Sunnica Energy Farm

Written representation relating to LGC Campus on behalf of HPUT A Limited and HPUT B Limited

PINS Reference: 20031202

Figure 4

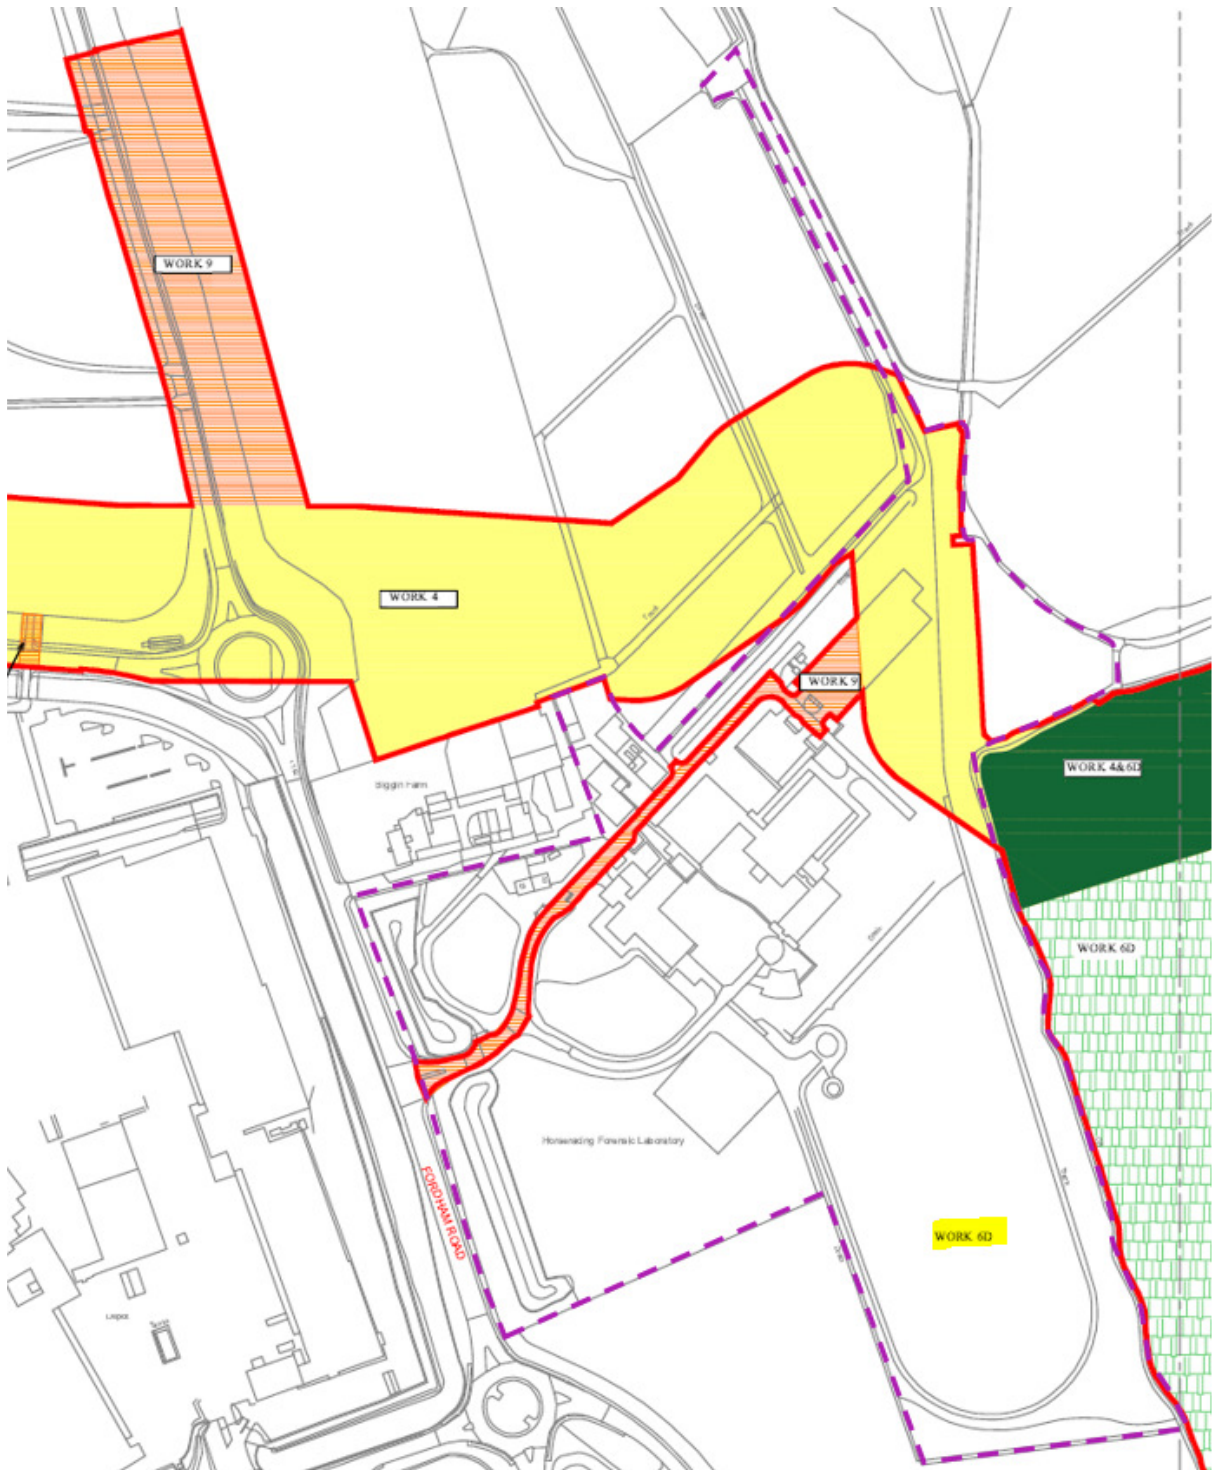
6.2 Figure 4 is an extract of sheet 16 of the DCO application's Works Plans (document reference APP-007) with the extent of the Campus dashed purple. It is not known why

Sunnica has annotated part of the Campus as Work 6D outside of the Order limits. **This is assumed to be an error to be deleted by Sunnica**, who is asked to address this urgently.

Figure 5

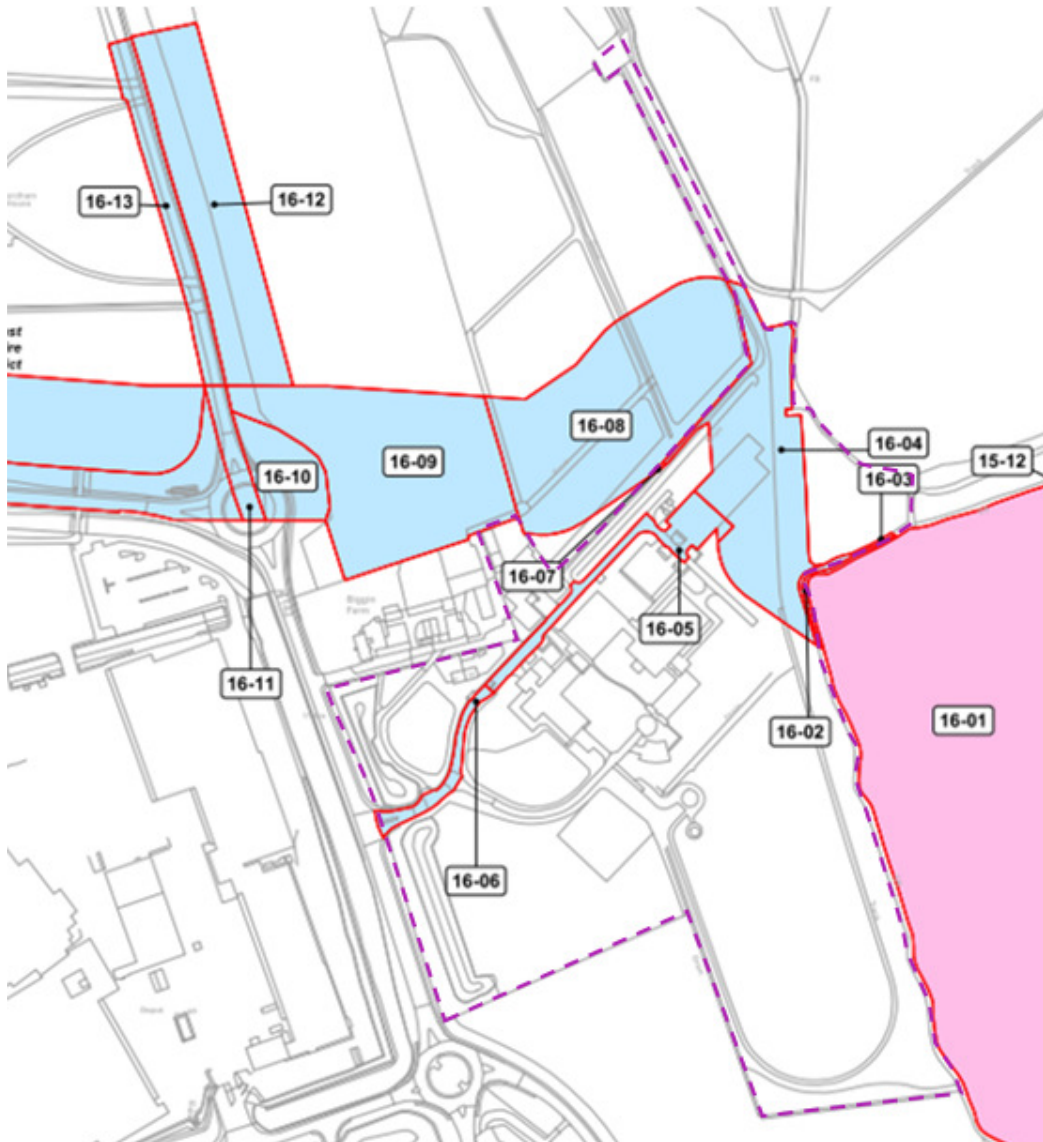
6.4 Sunnica is also seeking wide-ranging powers under the DCO to extinguish existing rights and create new rights over the following Parcels comprising a substantial part of the Campus (shown on Figure 5 below, being an extract of sheet 16 of the DCO application's Land Plans (document reference APP-006) with the extent of the Campus shown dashed purple):

- 6.5 The definitions of the rights sought over Parcels 16-04 to 16-07 (inclusive) are wide-ranging:
- 6.5.1 **“Access Rights”** are defined as rights over land to form, retain, alter, maintain and use means of access to the authorised development and to remove impediments to such access; and pass and re-pass on foot, with or without vehicles, plant and machinery (including rights to lay and use any temporary surface) for all purposes in connection with the authorised development.
- 6.5.2 **“Cable Rights”** are defined as rights over land to:
- (a) install, use, inspect, alter, maintain and remove electrical underground cables, earthing cables, optical fibre cables, and other cables and services, works

Figure 7

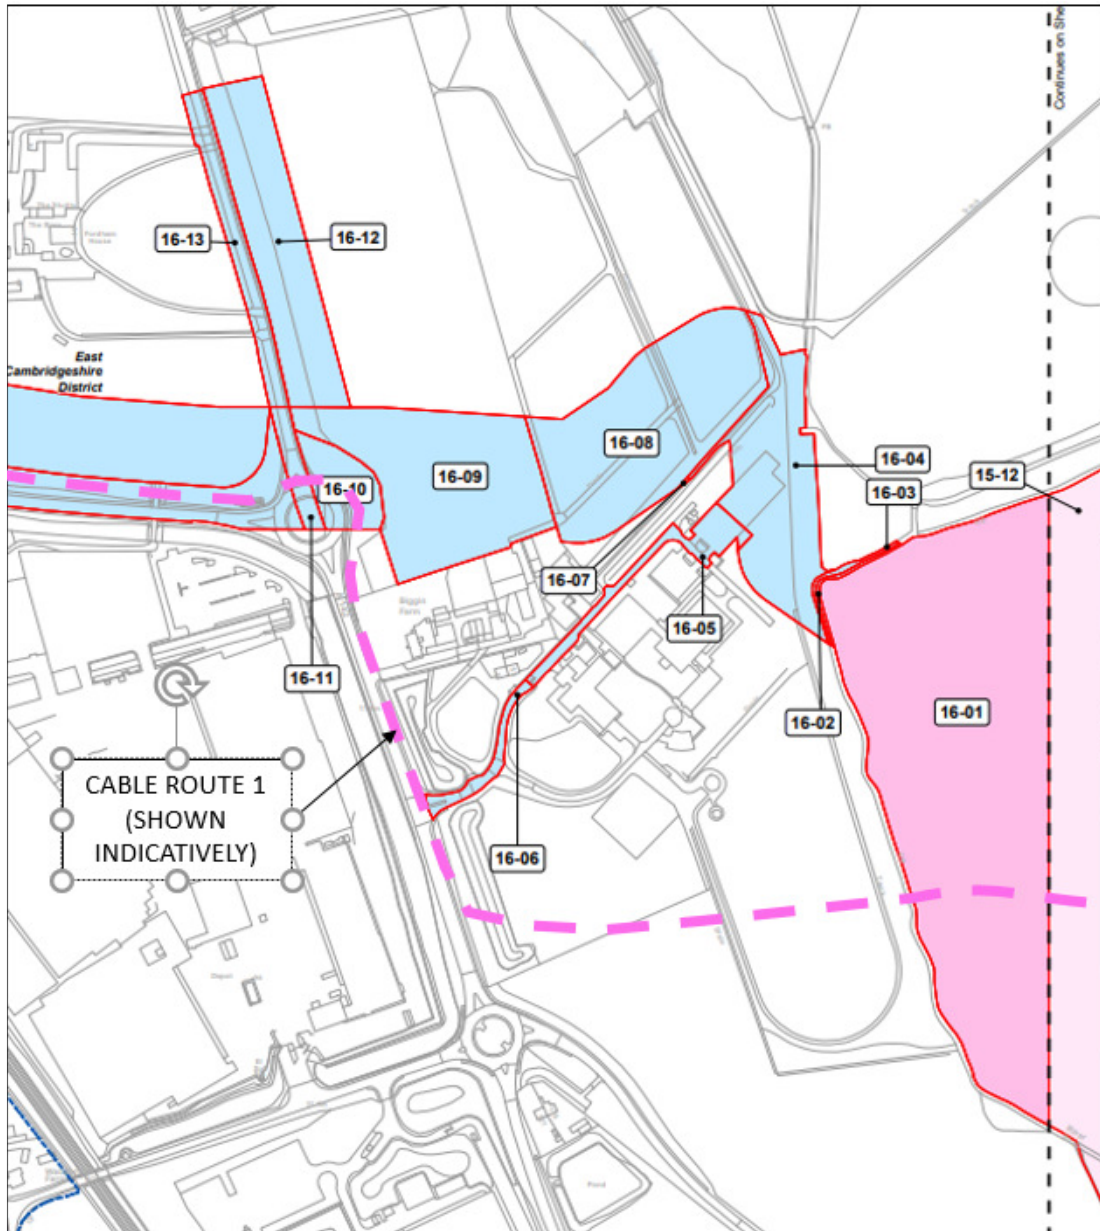
- (b) FHPUT's transport consultant, Caneparo Associates, has indicatively overlain Option 1 over sheet 16 of Sunnica's land plans to show its relationship with the Campus in Figure 7 below. It would appear that Option 1 might have encroached into the southern part of the Campus (compare against Figure 5 at paragraph 6.4 above), currently undeveloped but subject to proposed development under the Campus Expansion:

- (c) Option 1, however, does not affect the Campus's access road and there appears to be no reason why Option 1 could not have been altered to divert to the south of the Campus entirely. For example, the indicative alternative cable alignment set out in Figure 8 below (dashed red) could have been considered with alternative access routes for construction and maintenance traffic:

Figure 8

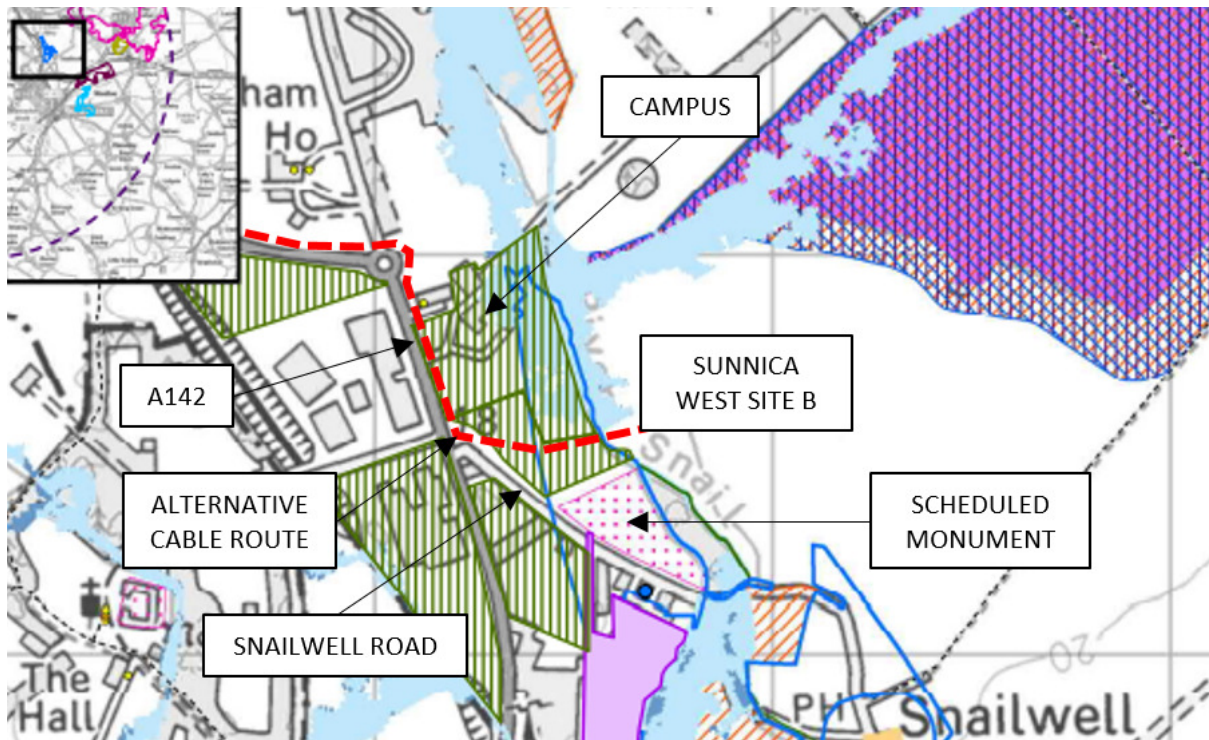
- (g) Temple Group Limited has carried out an appraisal of the cable route options on behalf of FHPUT to identify any relative constraints and potential environmental effects posed by the variation of Option 1 shown in Figure 8 above. It concluded that there do not appear to be any such constraints or effects that would render such a variation on Option 1 unacceptable.

Figure 9

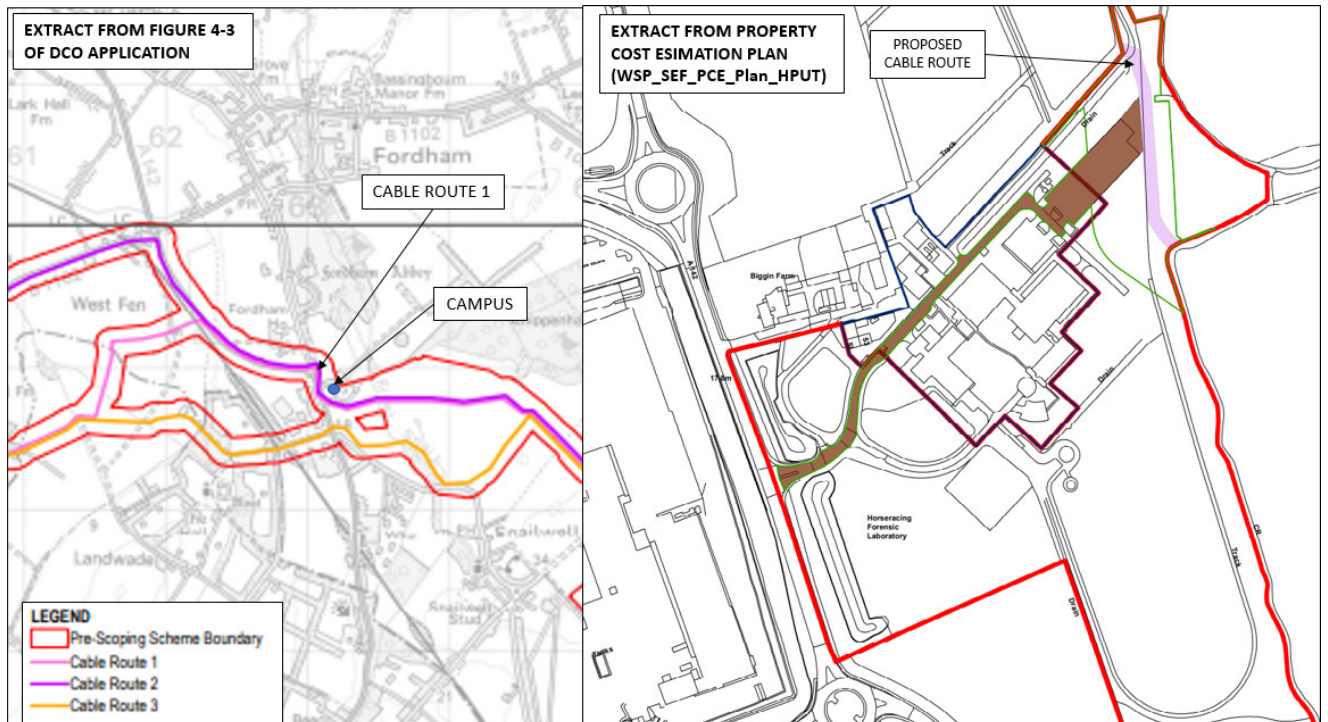
- (d) Notwithstanding the apparent selection of Option 1, the actual alignment of the cable corridor in the DCO application (the “**DCO Cable Route**”) does not follow the route of Option 1 shown in Figure 4-3 of Sunnica’s ES (document reference APP-173), or follow a reasonable variation of it to divert to the south of the Campus as per Figure 8 above. Instead, the DCO Cable Route is now located to the north-east of the Campus and partly within it. A comparison of Option 1 from Figure 4-3 of the ES (document reference APP-173) against the DCO Cable Route alignment on a supplementary plan issued to FHPUT by WSP entitled ‘Property Cost Estimation Plan’ (Drawing Reference 70050915-220301-WSP-PLN-AAA-001-LH-0’ Rev 0) is shown in Figure 9 below:

Figure 10

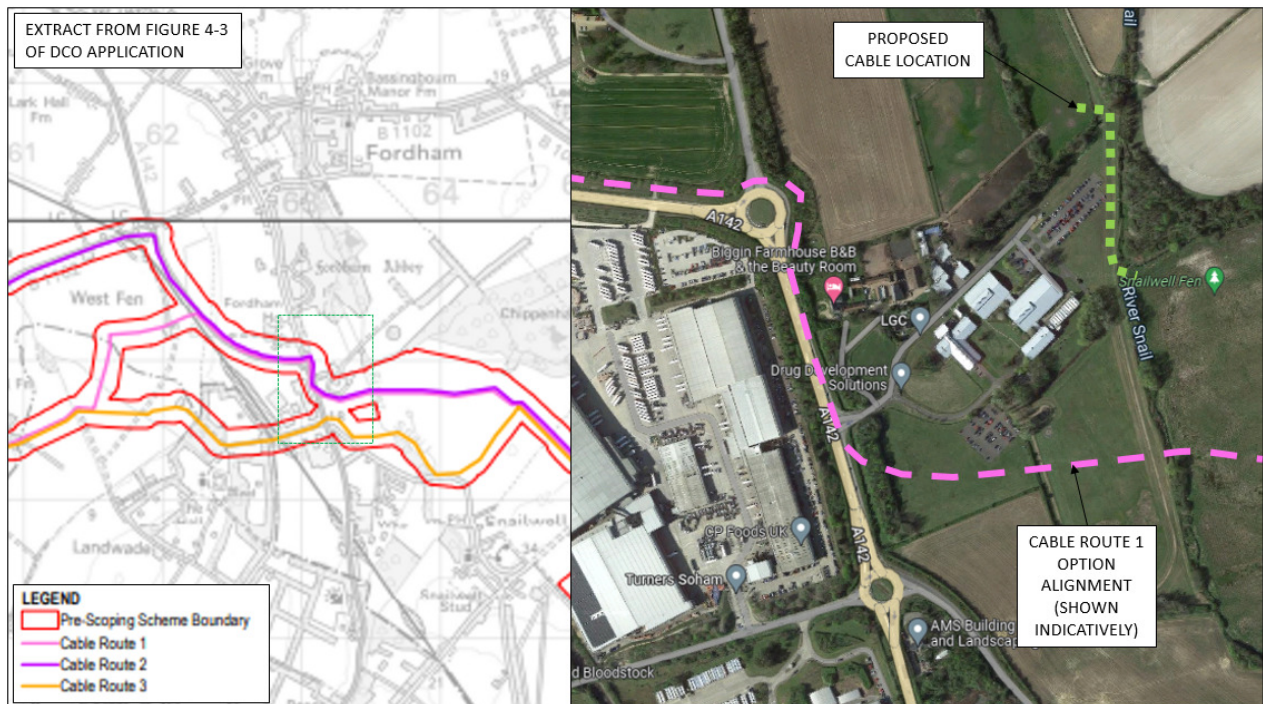
- (e) FHPUT's transport consultant (Caneparo Associates) has overlain Option 1 from Figure 4-3 of the ES (document reference APP-173) and the DCO Cable Route onto an aerial image of the land in the vicinity of the Campus in Figure 10 below:

- (f) FHPUT has been unable to identify any explanation in the DCO application documents for the rejection of Option 1, or a variation of it to route to the south of the Campus, in favour of the DCO Cable Route. The alignment of the DCO Cable Route directly impacts the Campus and requires construction traffic to route along its access road. A variation of Option 1 would have avoided impacts on the Campus and would not require construction traffic to use its access road. It is noted that Table 4-4 of Chapter 4 of Sunnica’s ES (document reference APP-036) considered the technical and engineering requirements as well as the planning, environmental, land use and ownership constraints of the three options and does not appear to identify any constraints that would render Option 1 unacceptable.

Figure 11

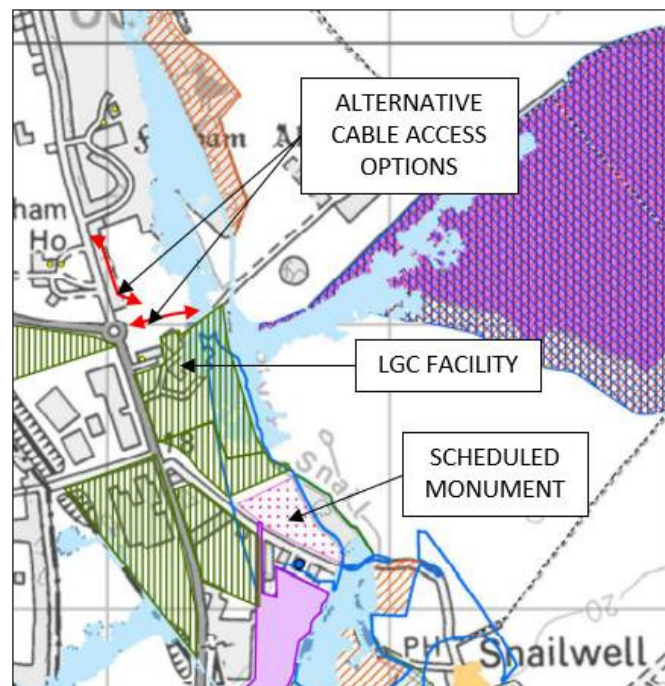
- (c) Even if there is some justification for the rejection of a variation to Option 1 in favour of the current proposal (which FHPUT has been unable to ascertain), there remain alternative access options available that would avoid direct impacts on the Campus. For example, it would be possible for construction and maintenance traffic to access the cable route via the road network to the north of the Campus, as shown in Figure 11 below:

- (d) FHPUT is unable to ascertain from the DCO application documents why alternative access arrangements, shown in the yellow dotted line on Figure 12 below would not be feasible to access the proposed cable alignment. This alternative routeing would not require construction and maintenance traffic to use the Campus access road. It would also appear to avoid any direct impacts on the Campus.

Figure 13

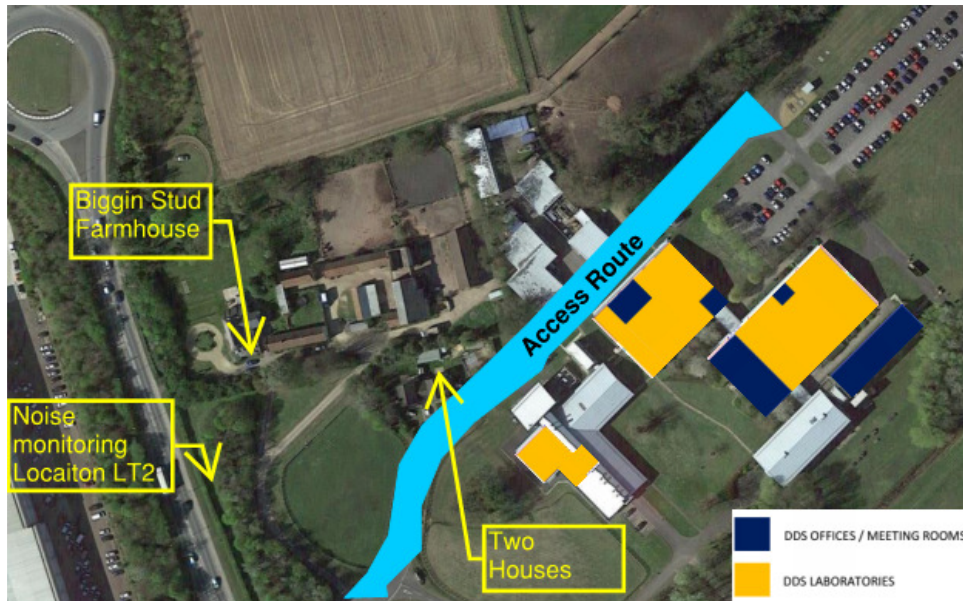
- 10.1.5 Sunnica's baseline noise monitoring exercise for Biggin Stud Farmhouse (R3) (again being the closest assessed receptor to the Campus) was carried out at a location adjacent to Newmarket Road (LT2) where baseline noise conditions are far higher than those within the Campus. Baseline noise data should have been gathered from within the Campus or a representative location unaffected by elevated traffic noise. As it stands, the monitoring location LT2 is not representative of noise levels at the Campus and is an unreliable baseline on which to assess the noise impact on the campus. R3 and LT2 are shown on Figure 13 below:
